FOAM MEMBRANE INC. AT THE BOTTOM OF SOGG. (2x2 oz).	
D	GELCOAT SEAL DID NOT RUN ALL THE WAY UP RUDDER TUBE	
C		
B	UPDATED WITH LLOYD'S RECOMMENDATIONS	
A		
ISSUE		MODIFICATION

DETAIL FROM DWG NO. M81052

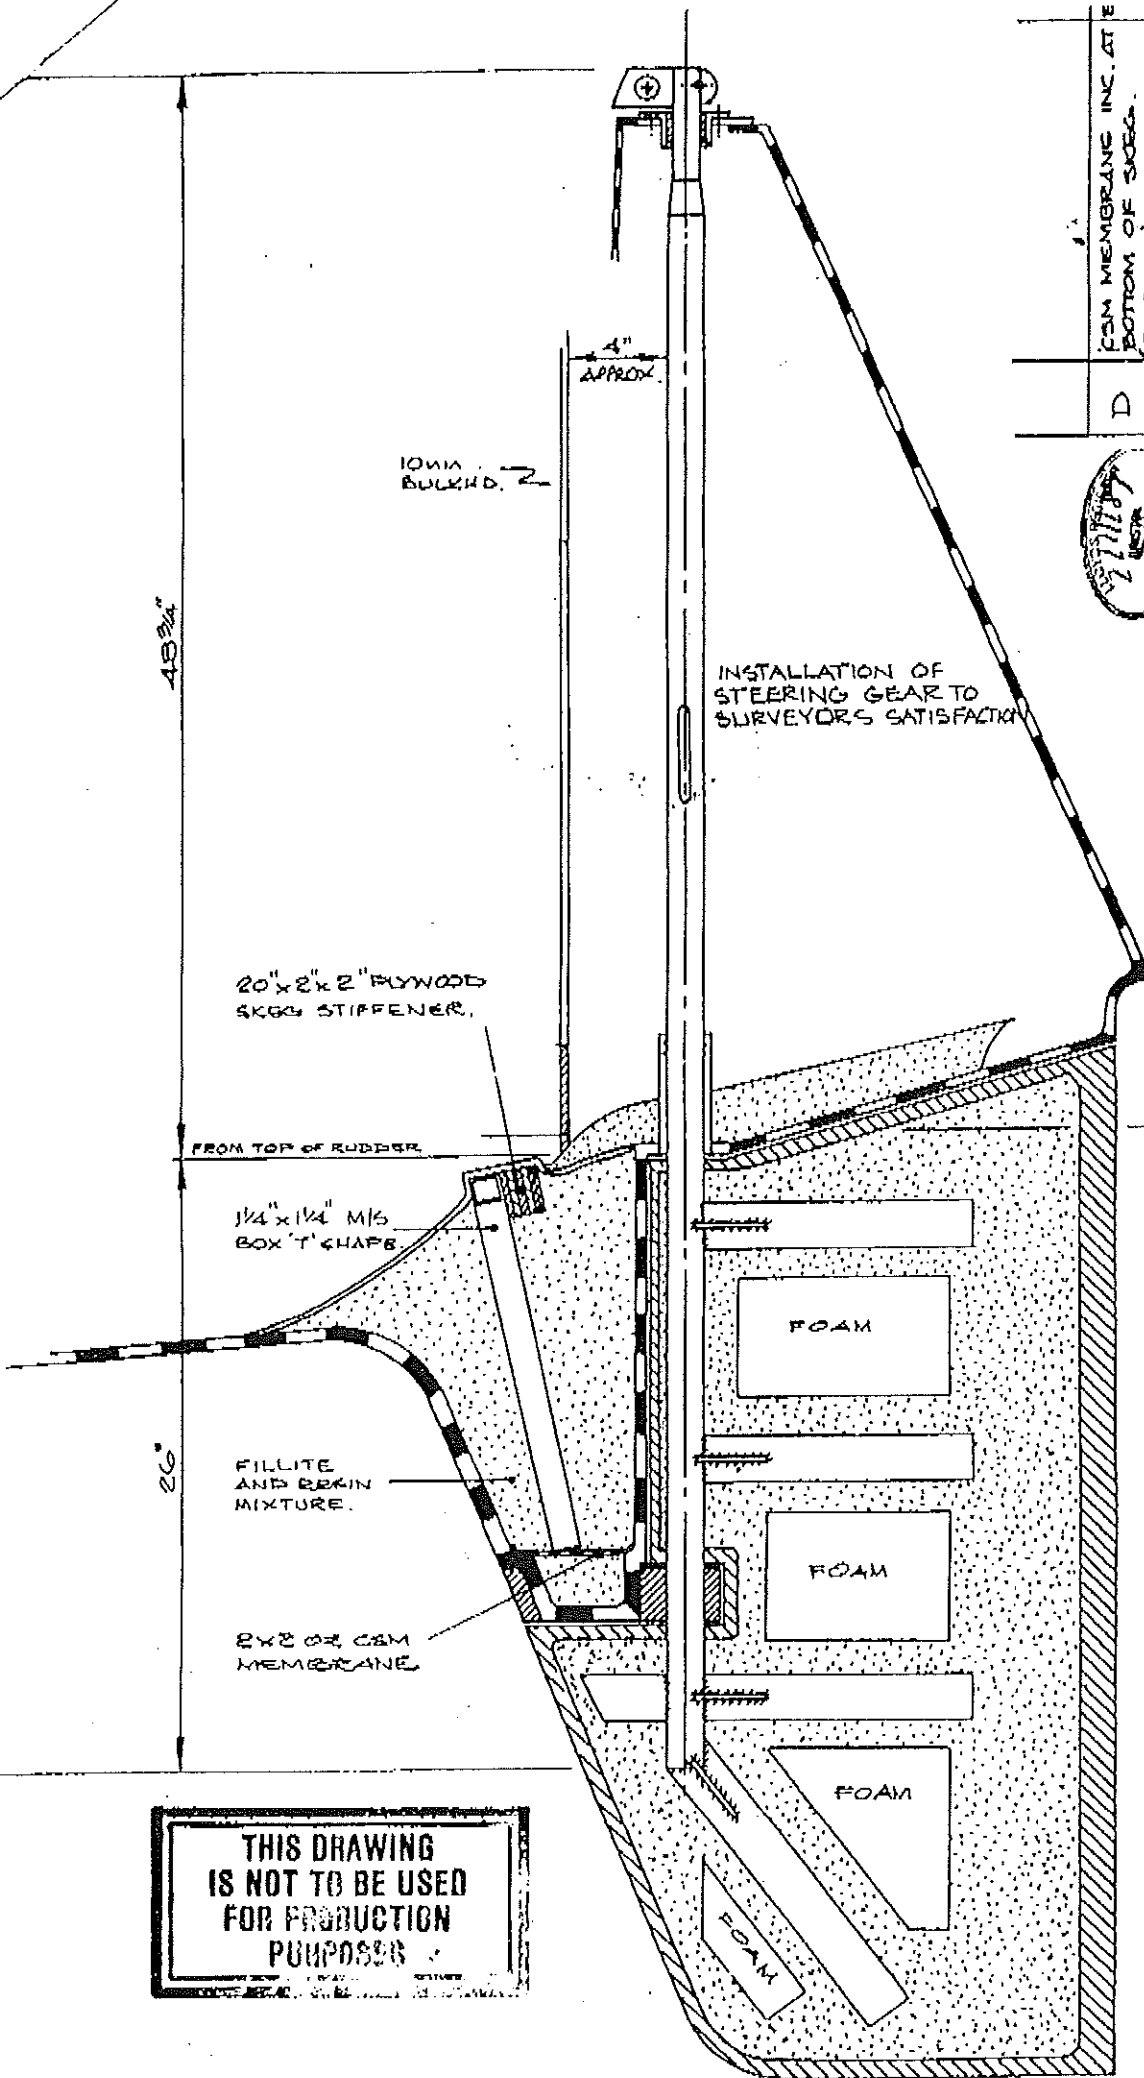
INSTALLATION OF STEERING GEAR TO SURVEYOR'S SATISFACTION
